AGENDA

CITY OF COLUMBIA TENNESSEE
BOARD OF ZONING APPEALS
STAFF REPORT

DOCKET/CASE/APPLICATION NUMBER
22-0183

REQUEST: Conditional Use (Extractive Use in an RS-40 Zone)

COLUMBIA QUARRY
- ZONING -
DRAINAGE

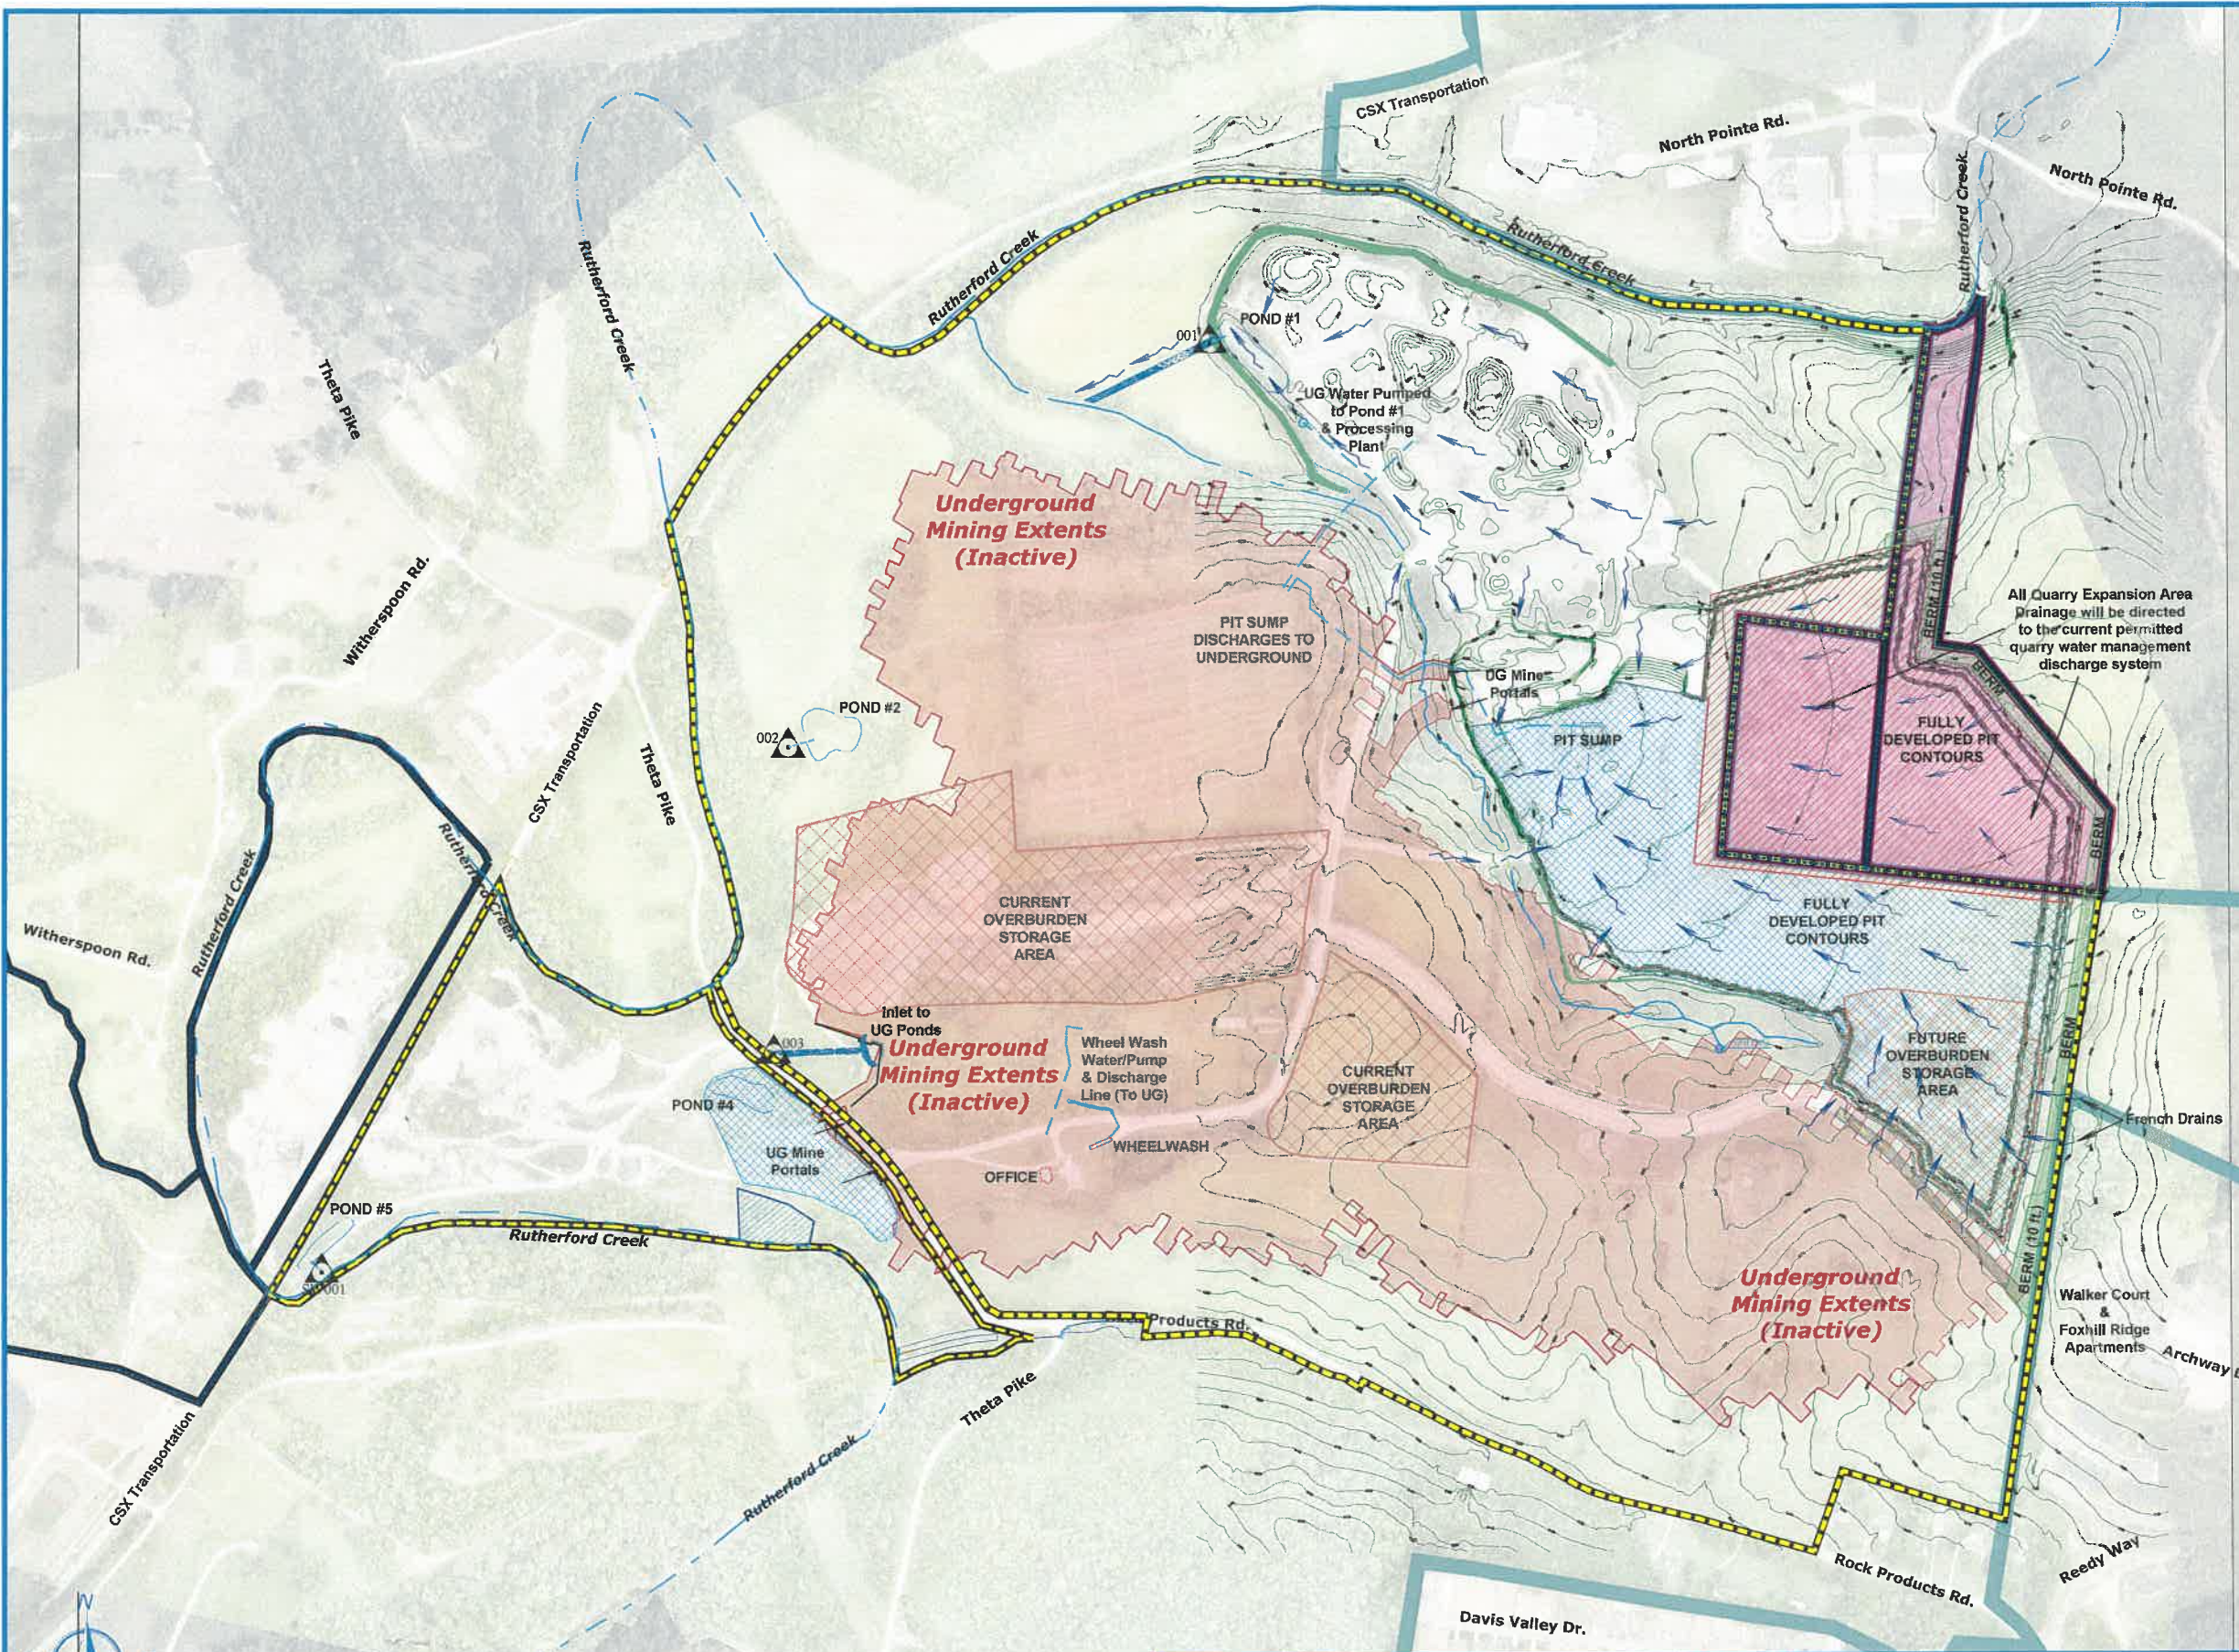
The Ordinance requires that a detailed site plan accompany every request to establish or expand a quarry operation (8.3.1.C.4). The applicant has provided a site plan comprised of Exhibits A through I of the submittal. The plan depicts the existing contours of the site and its vicinity at 2-foot intervals (8.3.1.C.4a and b), the method of drainage (8.3.1.C.4d), and the plan for restoring the site (8.3.1.C.1 and 8.3.1.C.4d).

COLUMBIA QUARRY
 - ZONING -
 FENCING

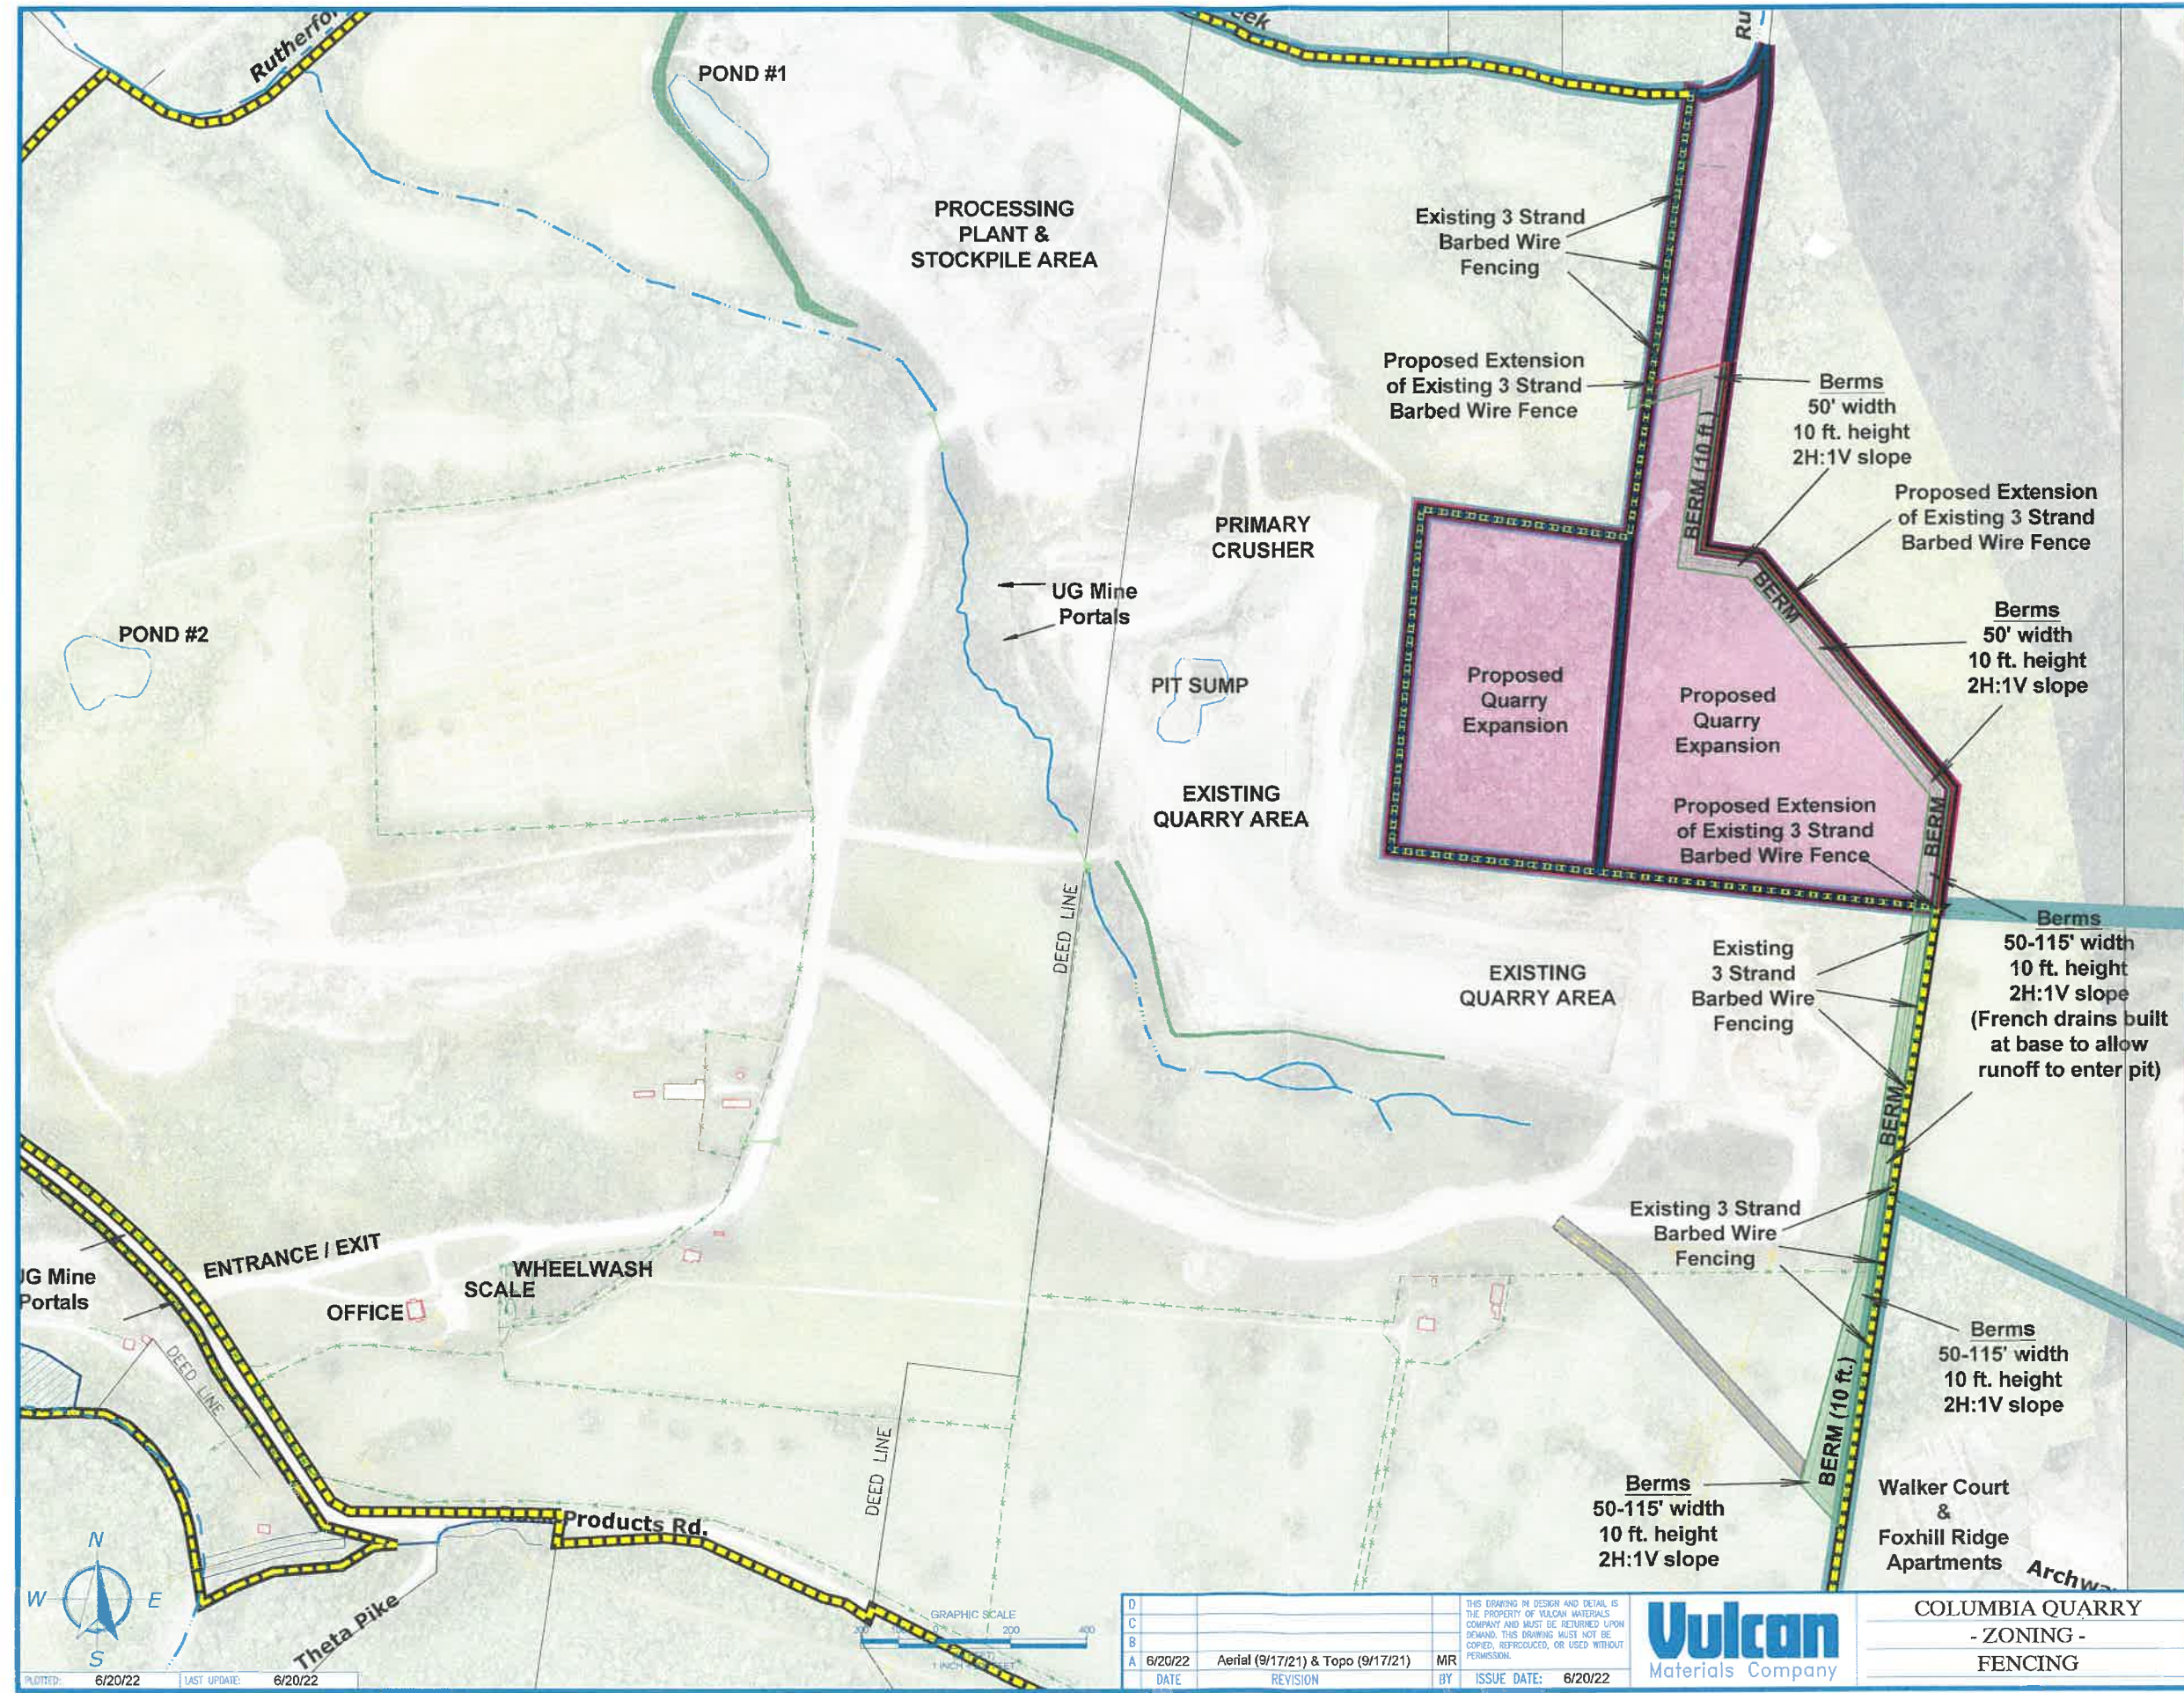
- d. Proposed method of drainage of the quarry area.
 - e. **Proposed fencing of the quarry area.** Fencing shall be provided around all open excavations.
